**Before the  
FEDERAL COMMUNICATIONS COMMISSION  
Washington, D.C. 20554**

In the Matter of )  
 )  
Application of Space Exploration Holdings, LLC ) File No. SAT-MOD-20181108-0008  
For Modification of Authorization for the )  
SpaceX NGSO Satellite System )

**COMMENTS AND PETITION TO DEFER**

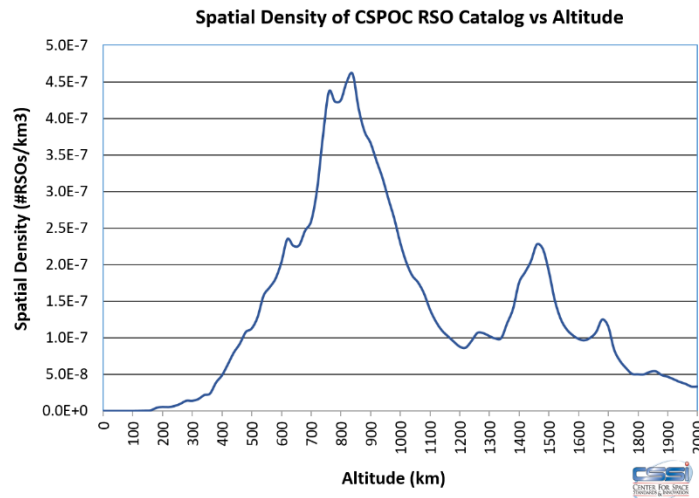
small satellite systems in this orbital region are not equipped with propulsion and use differential atmospheric drag to execute avoidance and deorbiting maneuvers. They operate at a lower level of control authority than propulsive systems, such as those operating at higher orbits, are readily capable of.<sup>4</sup> Indeed, the sub-600 km region is uniquely valuable to systems that operate without propulsion due to their reliance on atmospheric drag. Granted that the movement of 1,584 satellites into any region of space will necessarily increase local collision risks, it will especially do so if placed into a region populated by spacecraft that require more time to manage their avoidance.<sup>5</sup> This risk will be particularly pronounced while SpaceX satellites undergo orbit-raising procedures, and the accuracy of their positional information is reduced.<sup>6</sup> For these reasons, the effects of the SpaceX Modification provide a salient concern for the safe operations of many small satellite operators.

CSSMA notes that SpaceX has previously discussed its requirements for safe operations in its response to a set of OneWeb *ex parte* letters,<sup>7</sup> requesting exclusive access to a 75-km radial buffer zone surrounding its own constellation. In its response,<sup>8</sup> SpaceX contested OneWeb's request in part on the grounds that it would be forced to change its own constellation design to accompany the restriction. SpaceX clarified that a smaller radial separation of 50 km would be sufficient for its system to maintain safe operations with respect to other NGSO constellations, including OneWeb's. By providing its own metrics for what it considers safe, SpaceX acknowledged that operating with some level of buffer would be necessary to ensure safe operations. In the concerned SpaceX Modification, SpaceX states that it expects its satellites to maintain their apogee and perigee to within 30 km. Not discussed, however, is the change in risk when other systems do operate within this safety margin. At the 550 km altitude, a 30-50 km buffer will overlap with the nominal altitudes of several non-propulsive systems, including those of Planet, Spire, Astro Digital, Kepler, and others. CSSMA reiterates that a careful study of these effects should be requisite for the approval of the SpaceX Modification.
